**PCN#20170119000**  
**Qualify 4mm pitch Carrier Tape for select DSBGA Devices**  
**Change Notification / Sample Request**

**Date:** January 19, 2017  
**To:** PREMIER FARNELL PCN

Green dot location for 13" reel

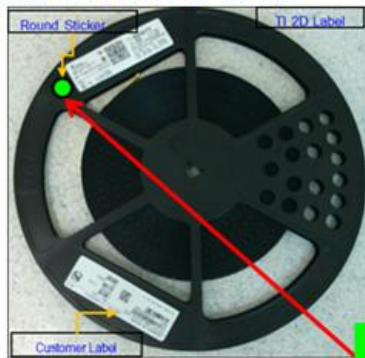
Green Dot Sticker added to 4mm Carrier Tape during Conversion
